Design Recommendation Meeting
6.22.2020
3033617-EG
3034294-LU
809 S Washington St

SECTION 02 / Board Guidance at EDG-2

Without Balconies
View From Yesler Park

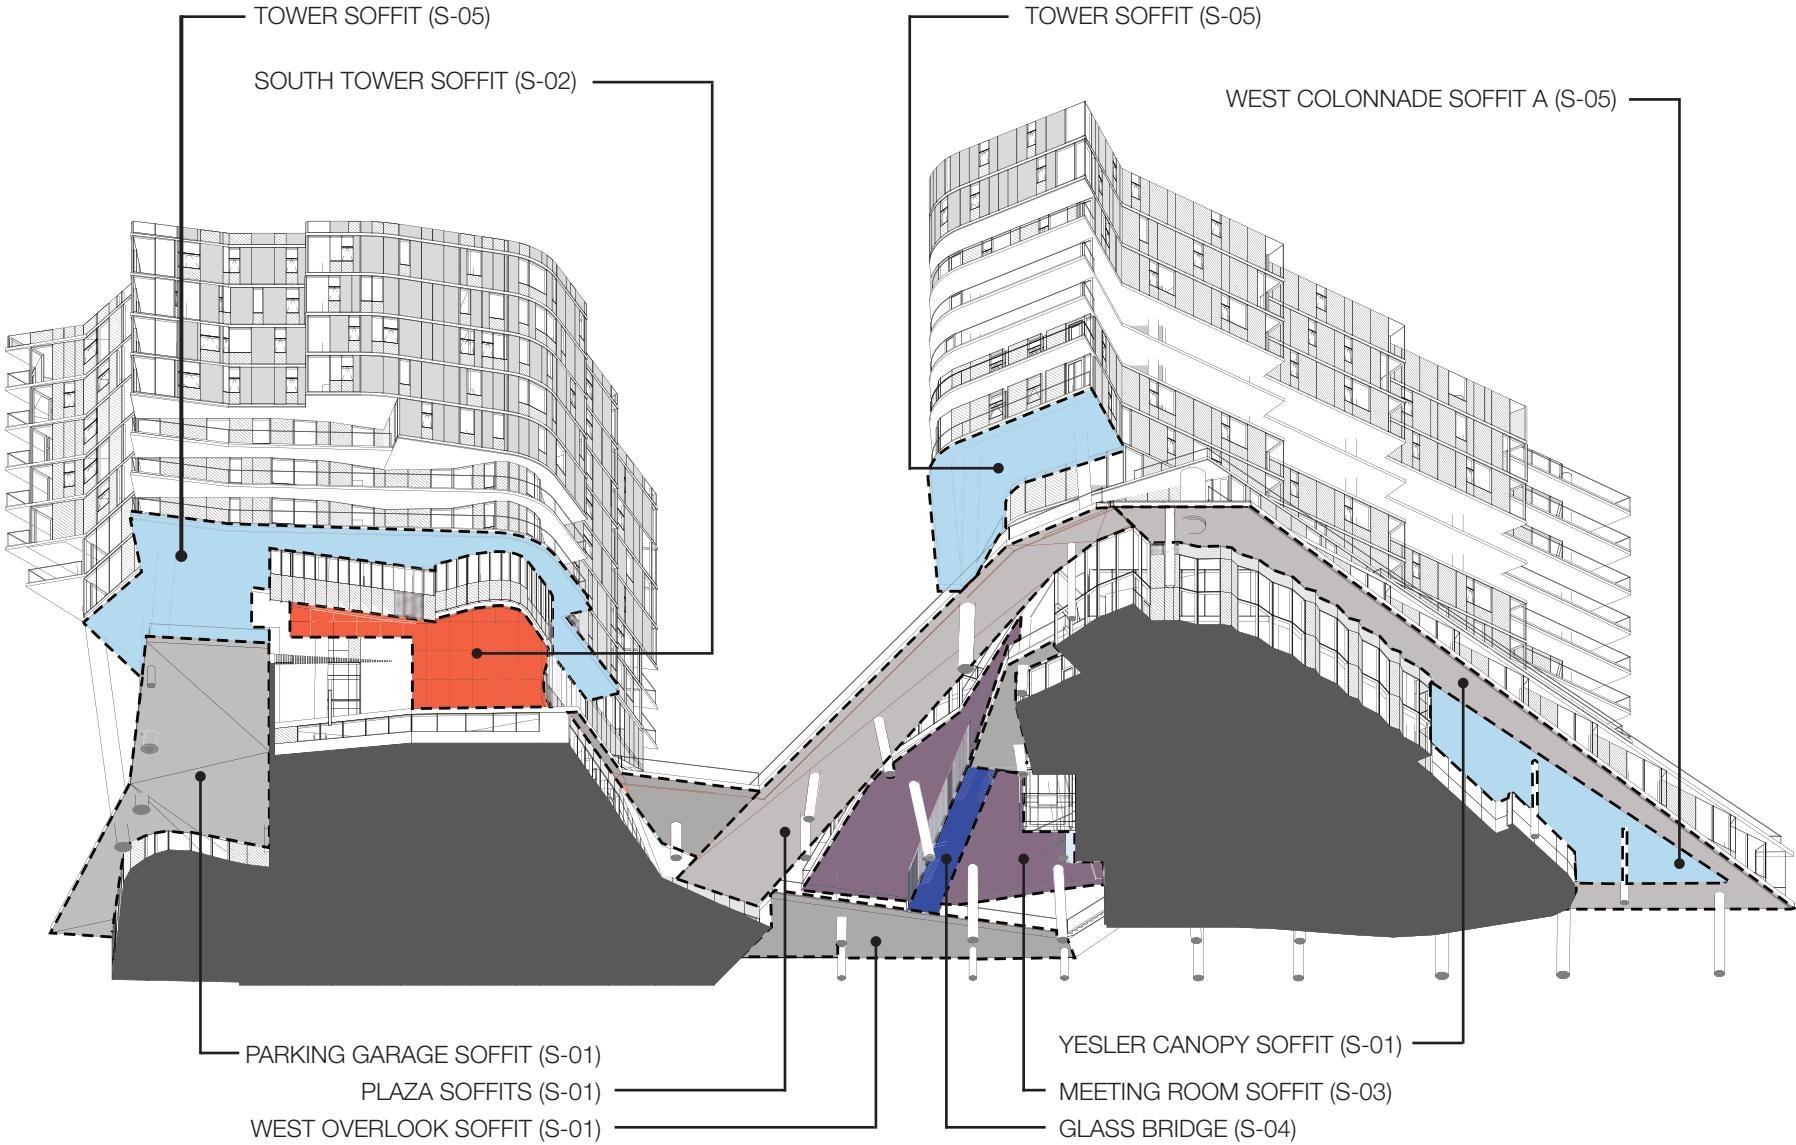
2.C: Regarding the balconies (see page 23 of the packet), the Board felt that the uppermost balconies on the south tower detracted from the elegance of the tower massing as viewed from the park. The Board recommended that these uppermost balconies be refined and brought into plane with the tower to be less distracting from the tower form and shape and better relate to the Phase I (north) tower. (DC2 Architectural Concept, Yesler Terrace DC2)

The highly visible tower forms respond to distant views within Yesler Terrace, on I-5 and throughout the city. The termination at the upper levels in an opportunity to introduce details and sculpture gestures which reinforce the formal concepts, while creating a human scale understood from a distance (DC2). The combination of sloping mechanical screens to emphasize prows-like edges and contrasting balconies create a balanced composition. Upper level balconies have been added to the north tower to unify the towers.

TOWER SOFFIT (S-05)

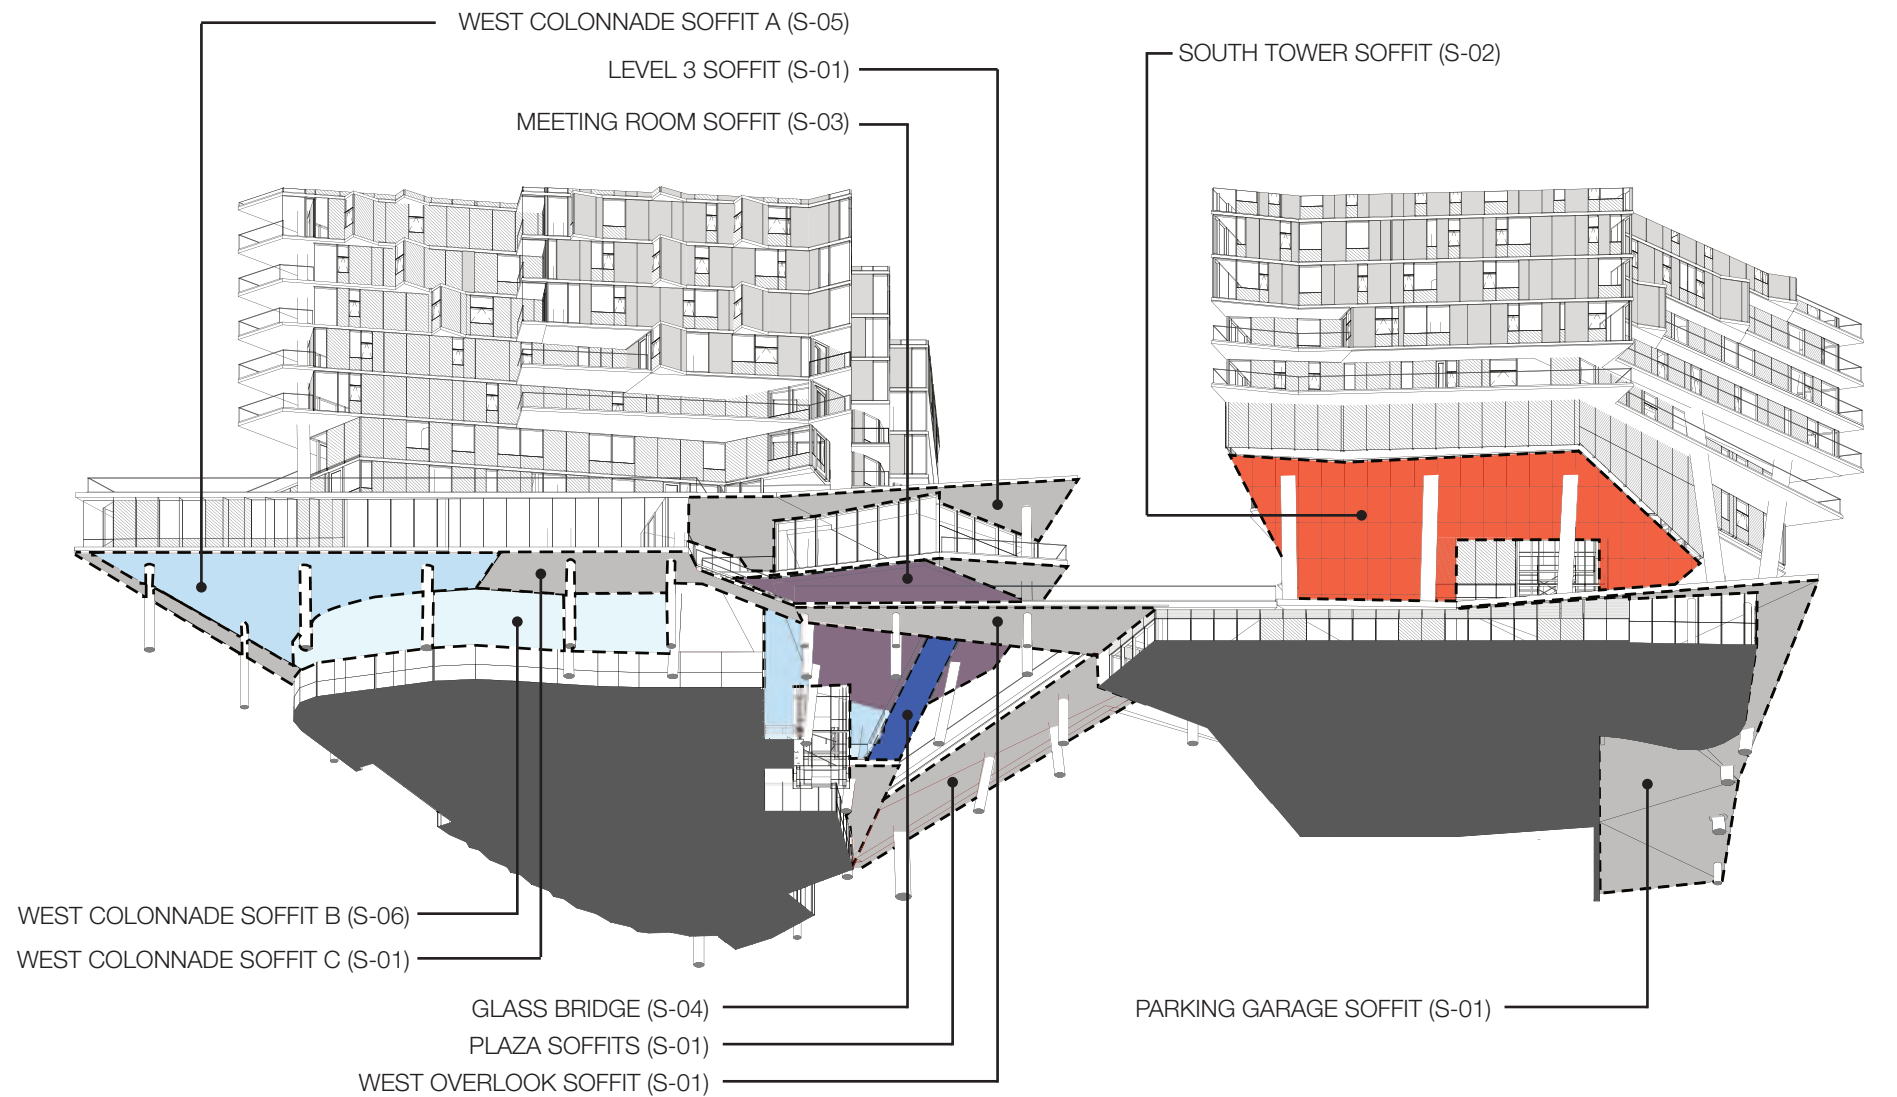
3A. Soffits: The Board noted that the views from I5 of phase II revealed that the soffit treatment of the podium will need to be thoughtfully considered as it is highly visible. (Yesler Terrace CS3 Neighborhood Context, PL2-B Safety and Security, Yesler Terrace DC1-C-2. Visual Impacts, Yesler Terrace DC4 Preferred Exterior Materials)

The Applicant acknowledges that the soffits will be visible from I-5 creating an opportunity for strong graphic elements that are legible day and night. The Applicant proposes the soffits include high quality finishes creating a variety of experiences. Materials considered for the soffits are primarily gray-toned to not overwhelm the eye or distract from the glassy towers. In some areas, color highlights are being studied to create “jewel-box” effects. Materials proposed are intended to be durable. The currently proposed material is Gypsum Wall Board as the base-case. Tensile Fabric is preferred for the color highlighted areas. The Applicant is also studying application of Glass, or Metal Panel in lieu of Tensile Fabric to make sure the material will be durable and perform well over time. We are requesting support for all of these material choices at the Recommendation stage so that we can continue development of the materials as the MUP progresses to final approval.

View of Garage Vine Wall from I-5 ROW

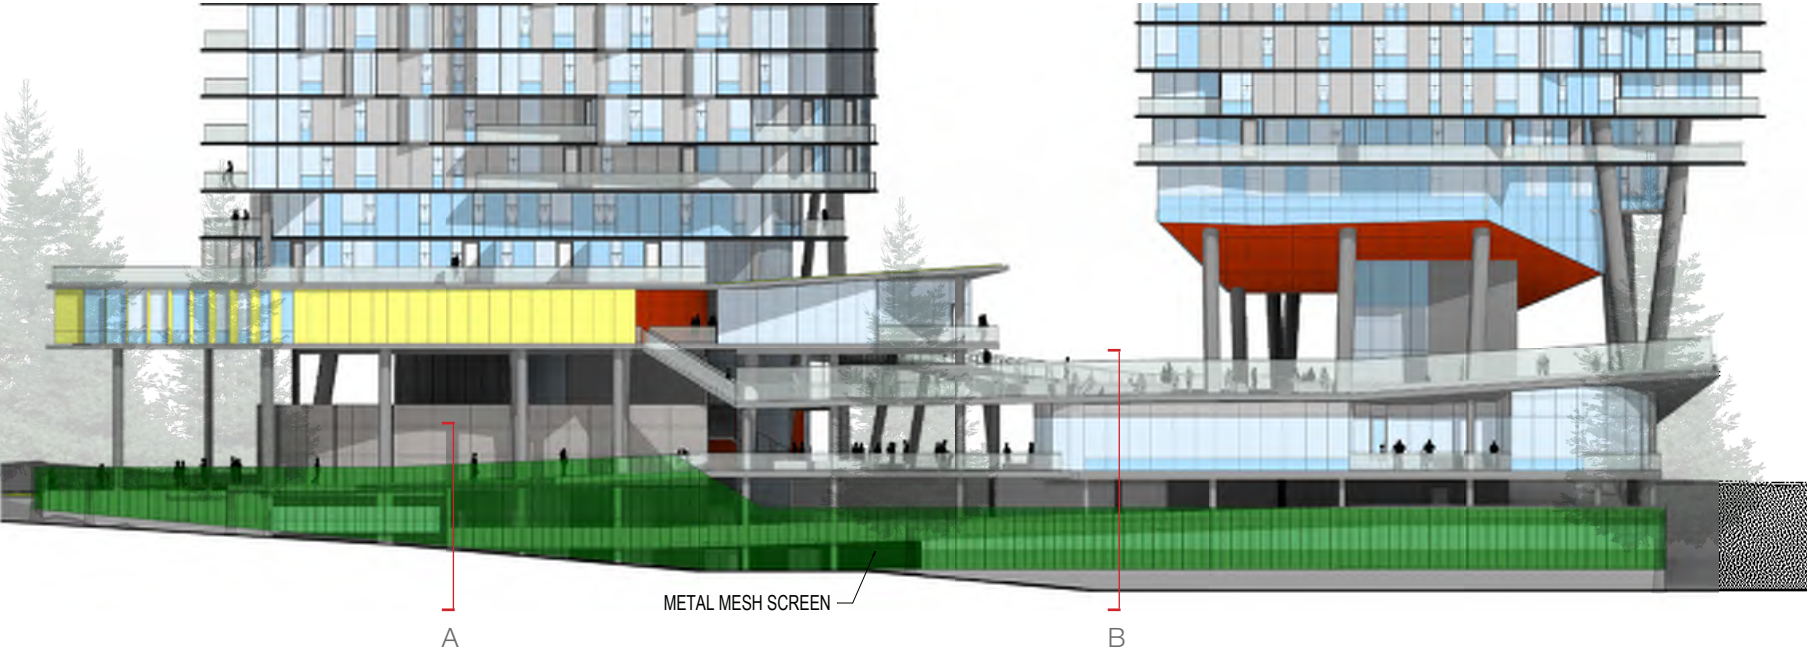
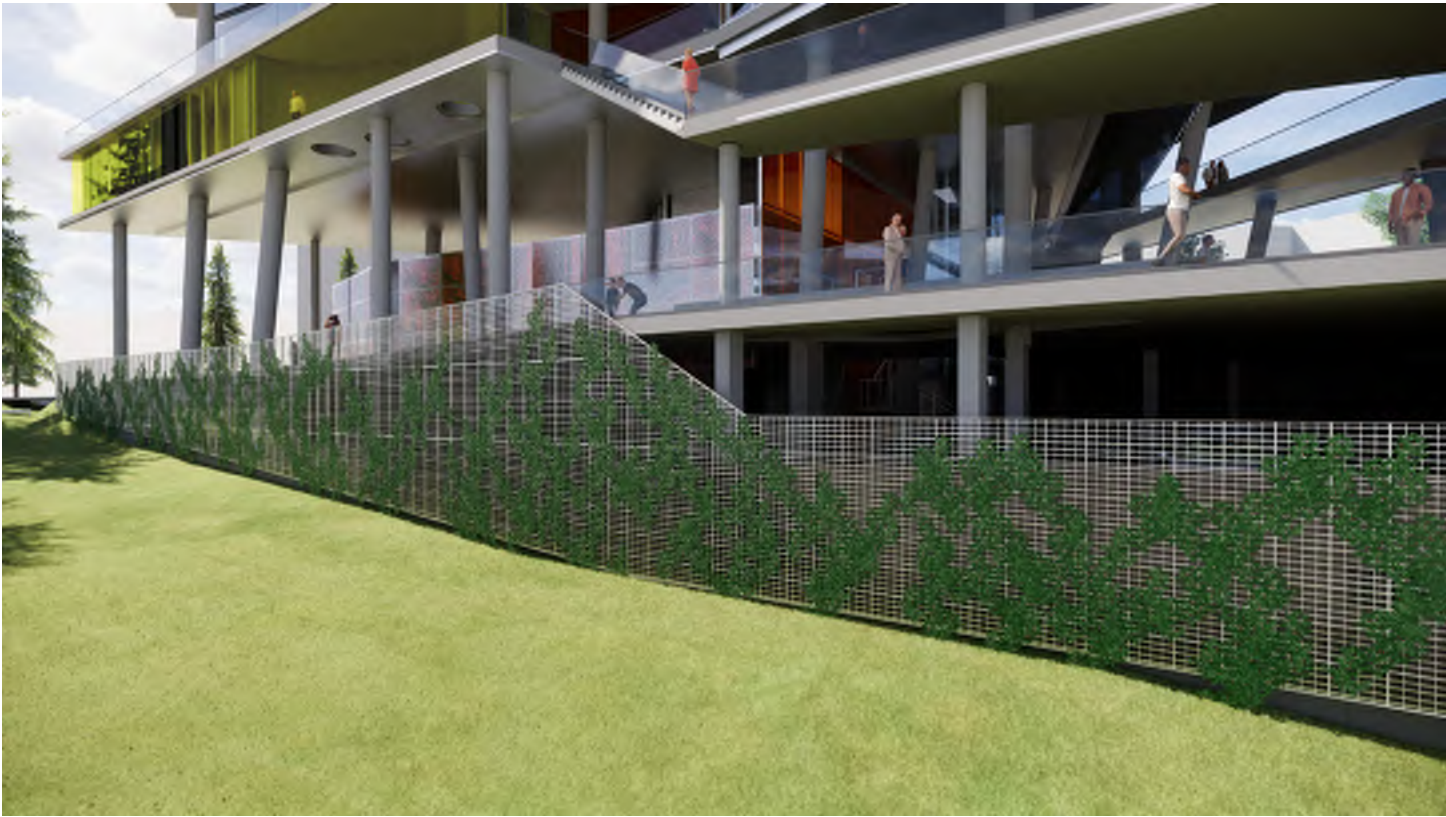
3B. Planting at Garage Screen: The Board discussed the vines proposed to screen the garage levels and suggested that the vegetation come from above rather than below so that the effect of the screening is more readily apparent. (Yesler Terrace CS3 Neighborhood Context, PL2-B Safety and Security, Yesler Terrace DC1-C-2. Visual Impacts)

3C. Parking Garage: The Board recommend further study of the parking garage so that the design either reads as very porous and transparent or heavy and grounded into the slope. Whichever approach is taken, the design should read clearly from I5 and integrate well into the strong landscape design plan. (DC1-B Vehicular Access and Circulation Yesler Terrace CS3 Neighborhood Context, PL2-B Safety and Security, Yesler Terrace DC1-C-2. Visual Impacts)

A metal mesh partially covers the open parking garage providing both a security screen, and armature for vines to grow on. Visually the mesh creates a transition from the heavy concrete base to the lightweight expression of the podium. Vines rising from the ground reinforces this transition. Options for vines hanging from above were studied and determined to be less effective with respect to plant establishment and long-term vitality. Limitation to soil volume on the raised deck/garage roof restricts plant success. The intent to open views from the plaza to the west is also restricted if vines cover the 42” tall guardrail along the edge of the plaza and further compress the view out from the plaza, and the light that is allowed to enter the space beneath the terrace canopies. Vines planted in the (ground) soil on grade along the west facade will thrive with long term access to good soil volume and drainage.

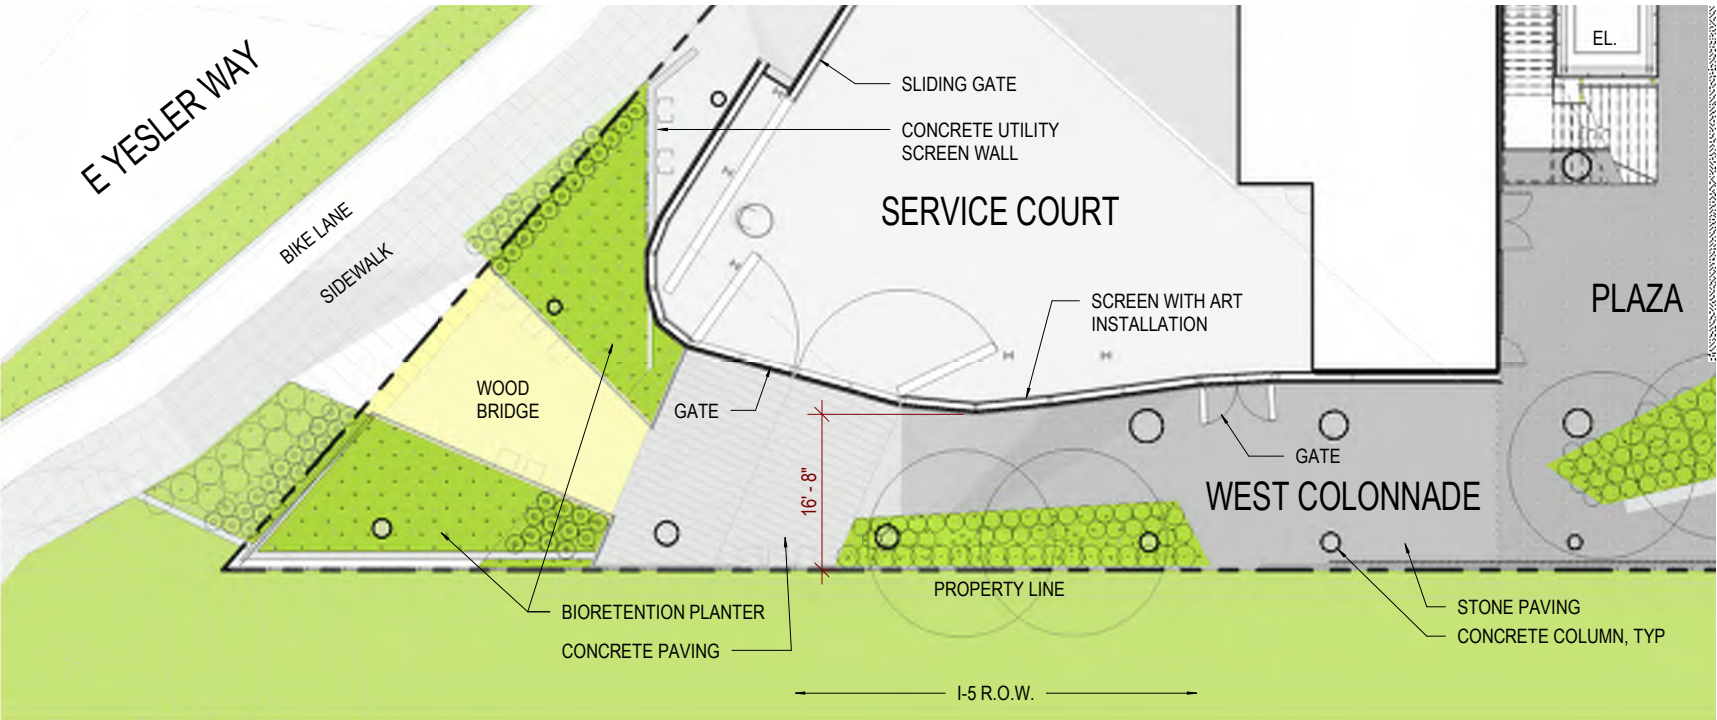
A. Shared Access Drive: The Board encouraged further exploration of the design of this shared access drive as a primarily pedestrian focused zone with vehicular use secondary. The Board suggested the use of removable bollards as one method for achieving the primacy of the pedestrian in this space while also allowing for food trucks, car share loading, etc. (PL1-B-1. Pedestrian Infrastructure)

i. The Board noted that the appearance of the service entry on Yesler Way will be critical at this highly visible location.

The Board stressed that this is a gateway location that the tower successfully establishes, but this same level of drama, coherence and interest needs to be carried down to the base at this location. The Board noted the following elements should be considered and addressed at the next meeting (DC1-B Vehicular Access and Circulation and Yesler Terrace Supplemental, Yesler Terrace CS1-E Water, Yesler Terrace CS2 Wayfinding Kiosks, PL1-B-1. Pedestrian Infrastructure):

- ii. Creation of a welcoming space along the street level;
- iii. Thoughtful and interesting design of the screen wall and garage doors/gates;
- iv. Alleviating the pinch point of the prominent building corner against the site corner;
- v. Promotion a safe and secure space;
- vi. Integration of exterior lighting to highlight the podium and this programmatic function;
- vii. Use of high-quality materiality;
- viii. Examine the potential for porosity through this space to the landscaping and views beyond; and
- ix. Explore use of landscaping and/or art to achieve the guidance above.

B. Street Level Perspectives: At the next meeting, the Board requested perspectives taken from the pedestrian level on the same side of the street (Yesler) as the subject site to really understand the space, views and sight lines. (DC1-B Vehicular Access and Circulation and Yesler Terrace Supplemental) Comment 6.c

Refer to Section 03 for development of vehicle access plaza.

Pedestrians will access the west edge of the site from Yesler Way via the wide accessible bridge over the bio-retention planter that introduces the on-site stormwater strategy along the edge of the public sidewalk. The colonnade will be an open double height space, welcoming the public into the podium. A partial height art installation screens the service court from the pedestrian areas, and provides a visual connection from the ROW to the Central Plaza. In contrast to the articulated screen, a smooth light gray GWB soffit reflects light into the space reinforcing the open airy quality.
